AMENDMENTS TO THE DRAWINGS

REMARKS

Objections to the Drawings

FIG. 9

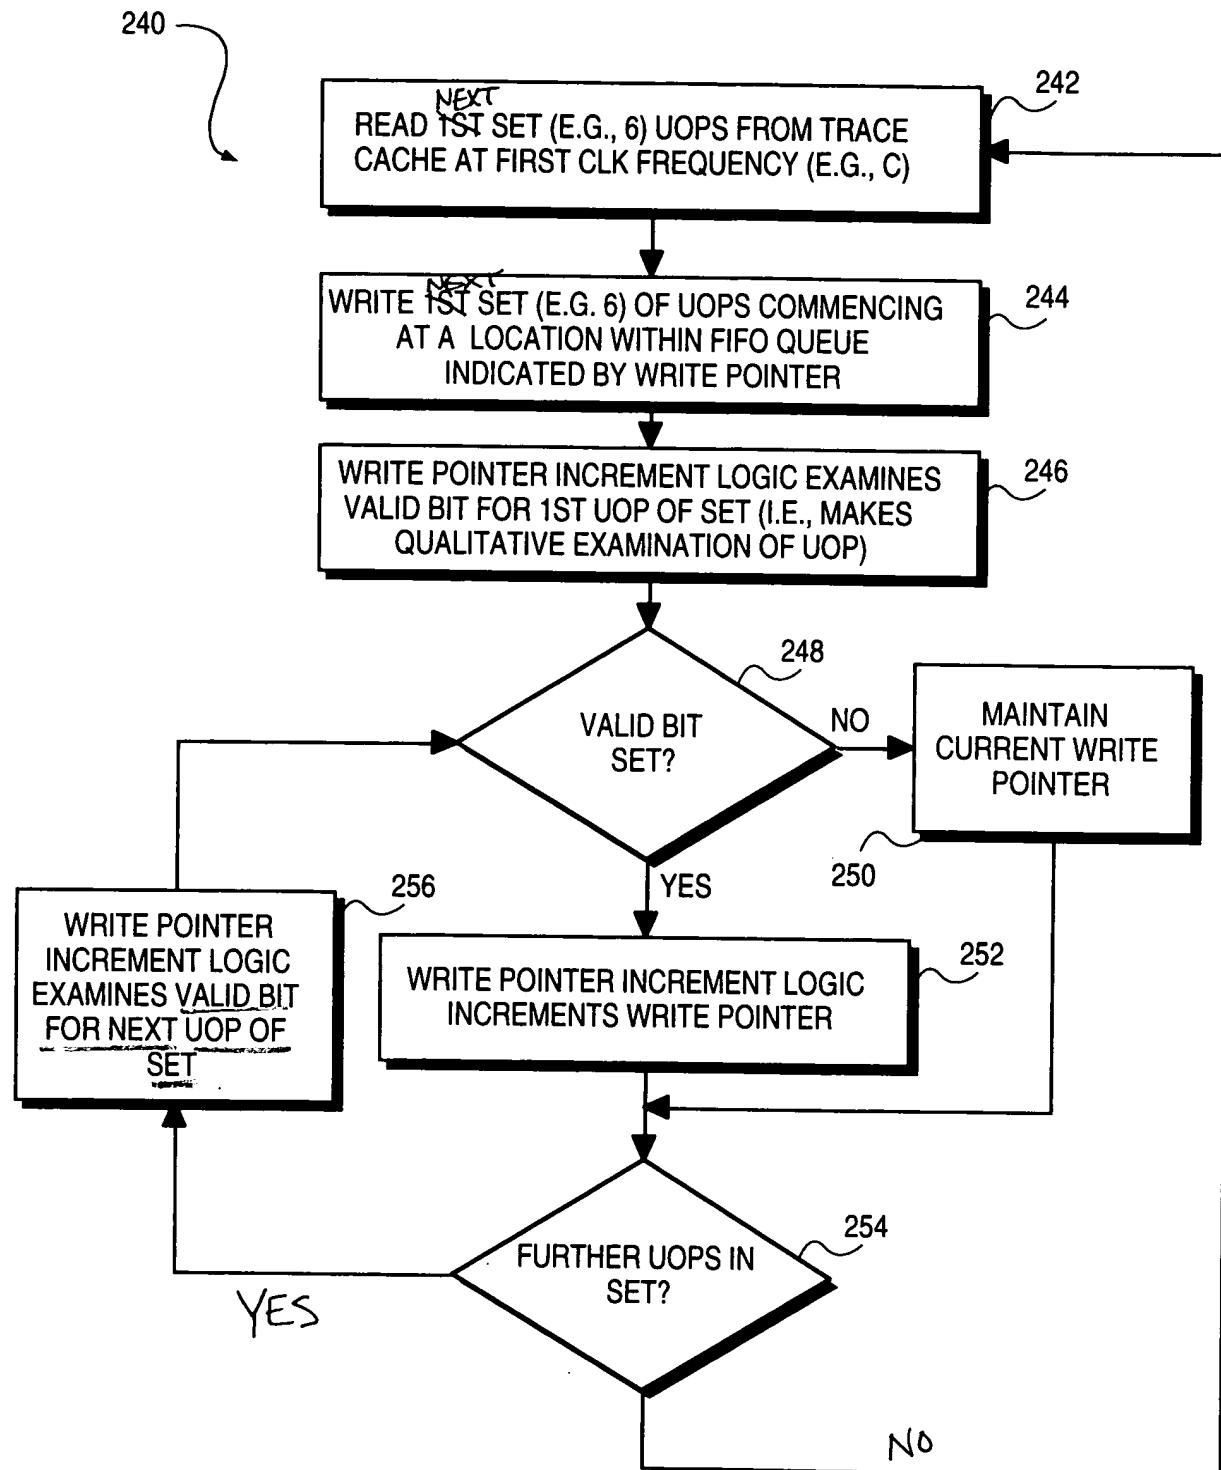
Applicants submit a replacement sheet and an annotated sheet of Figure 9 (appended hereto) for approval by the Examiner in accordance with MPEP § 608.02(v). The proposed replacement sheet is submitted to comply with the Examiner's request to label the paths emanating from block 254 and to clarify blocks 242 and 244.

The Examiner further objects to Figure 9 on the basis that Figure 9 and the specification disclose something different from the claims. In particular, the Examiner refers to "if the qualitative determination is to retain the first microinstruction, then advancing the write point ... if the qualitative determination is not to retain the first microinstruction, then maintain the write pointer" as recited in claims 1, 13, and 21. Applicants respectfully submit that on page 22 of the specification, in lines 11-21, it is described that the write pointer will proceed to the entry following the last valid microinstruction in that set. A new set of microinstructions will be written at the end of the previous set if the previous set contained a full compliment of valid instructions, or overwrite the invalid entries. Applicants respectfully submit that the description stated in the specification is consistent with the claim language and that which is depicted in Figure 9.

Figure 9 has been amended to include labels "YES" and "NO" for the paths emanating from block 254. Furthermore, Figure 9 has been amended to indicate "Read next set (e.g. 6) upos

from trace cache at first clk frequency (e.g., C)" at operation 242 and "Write next set (e.g. 6) upos commencing at a location within FIFO queue indicated by write pointer" at operation 244. These amendments are supported by the Applicants' specification as filed on page 22, lines 8-10.
